RE: DRAINAGE PLAN FOR SUMMIT HILLS
(J-23/D9E) RECEIVED FEBRUARY 19, 1987

PROJECT TITLE: SUMMIT HILLS ZONE ATLAS/DRNG. FILE #: J-23^{DAE}

DRAINAGE PLAN

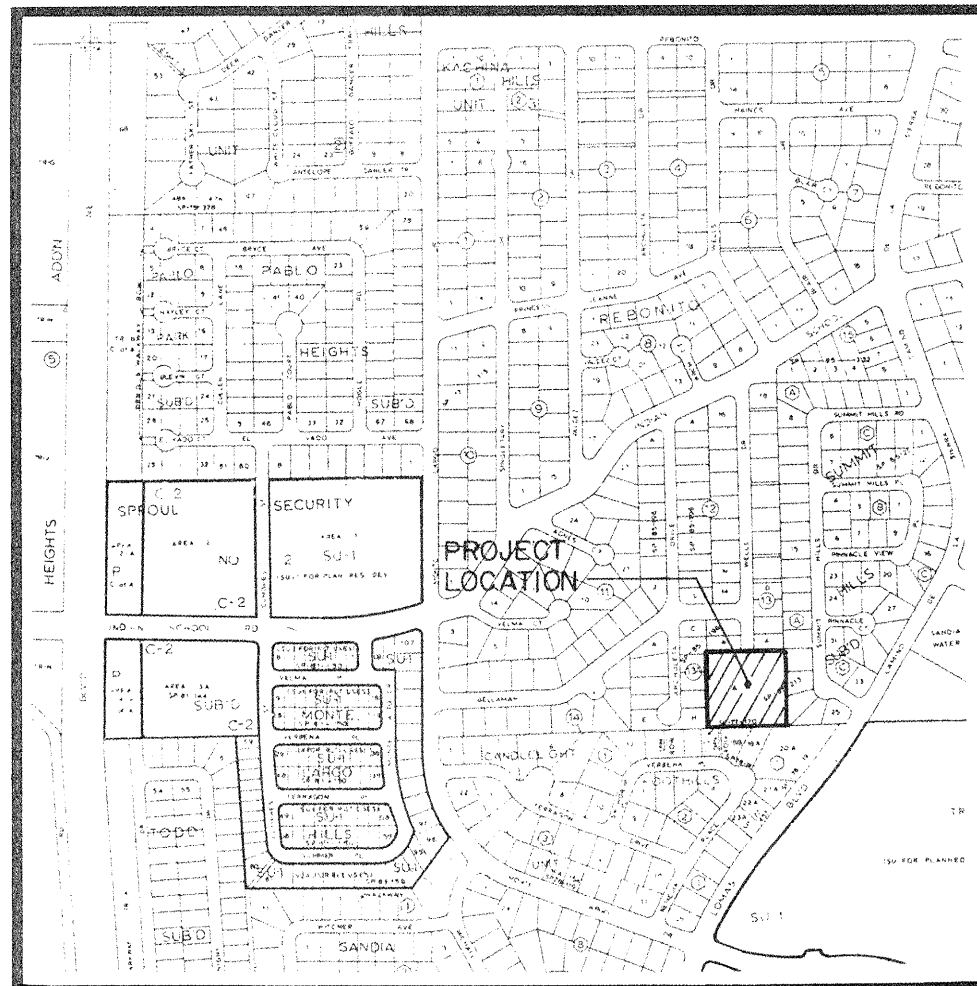
The drainage plan submitted is no longer applicable. The new plans being processed through DRC use a pipe instead of a concrete channel. The DRC chairman and the owner are in discussion as to who will be responsible for the costs.
